**MANDATORY**  
**SERVICE BULLETIN**  
**MSB-2009-001**

**DATE:** August 31, 2009

**SUBJECT:** Revised Support Clamps

**MODELS AFFECTED:** All Cessna 177RG aircraft with PFS-13706 exhaust systems installed (See Table 1 for Aircraft Applicability).

**Figure 1**

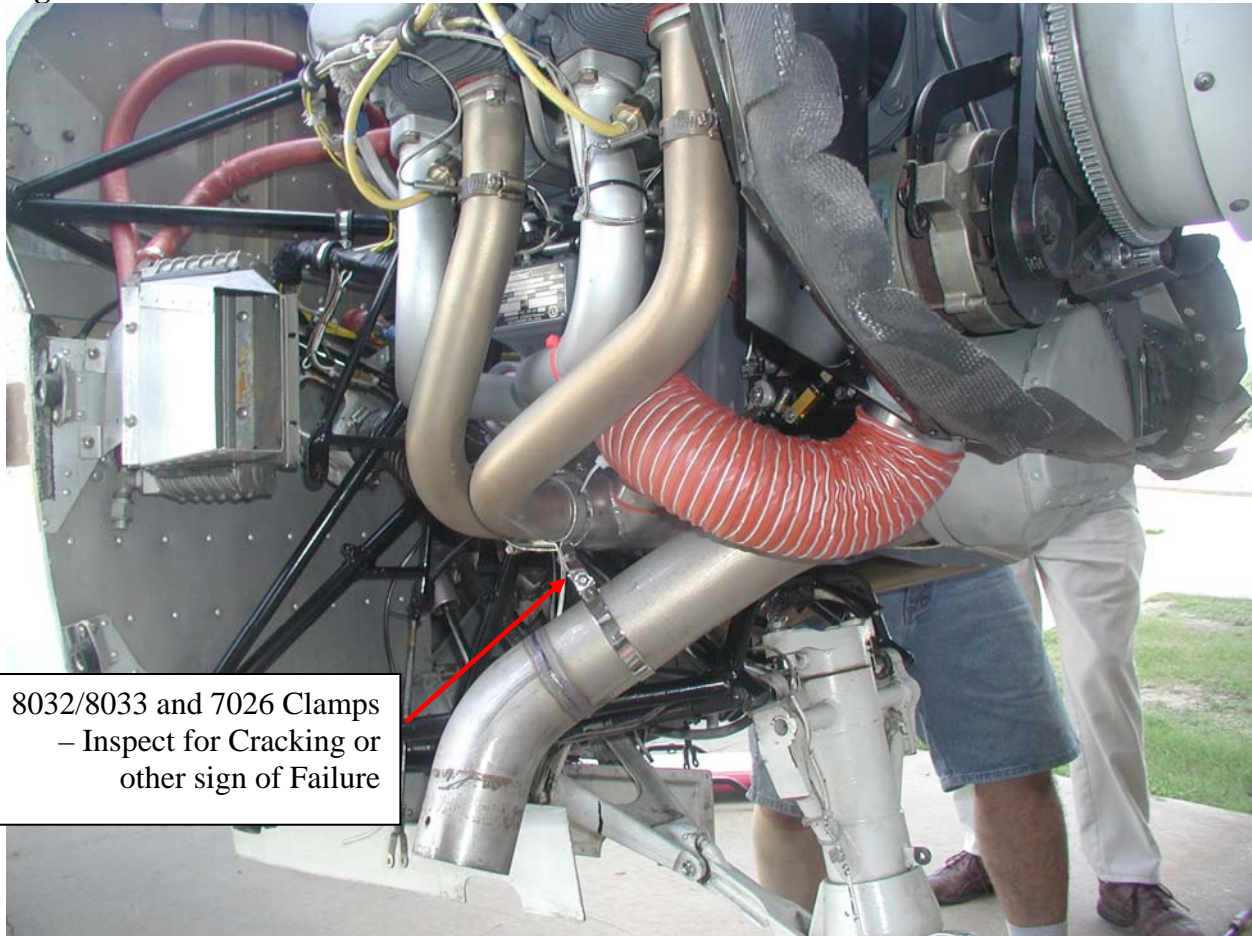
**DESCRIPTION:** In the short time since the introduction of this exhaust system, there have been several failures of the P/N 8032 and 7026 clamps that attach the intermediate tube to the number one header pipe. While this is not the only means of securing the intermediate tube to the rest of the exhaust system, the clamp does help ensure proper tailpipe angle. The original clamps were 0.63" wide.

We have developed two wider (1.00" wide) replacement clamps (P/N 8033 and 7026 Rev A) and will be providing them free of charge to all affected customers. Please inspect both clamps before your next flight, looking for cracking or detachment. If either clamp is cracked or has otherwise failed, replace both with the new clamps before further flight. If the clamps are not cracked or otherwise damaged, you may continue to use them until the next scheduled maintenance (oil change, annual, etc.). If you elect to continue to use the clamps, note how much tailpipe movement is present. If a future preflight inspection yields more tailpipe movement, the clamps should again be inspected.

**CORRECTIVE ACTION:** Install the clamps included with this Service Bulletin.

Remove the existing clamps by removing the hardware that joins them. Install the new clamp in the same manner as the original, discarding the old clamp. Please keep in mind that if you did not receive two clamps, you will need to reuse the 8033 clamp (the larger of the two). It may be necessary to pull forward on the bottom of the intermediate tube while tightening the clamps to ensure sufficient clearance to the engine mount. See the included installation instructions for additional details. Make a logbook entry stating that you have complied with this service bulletin.
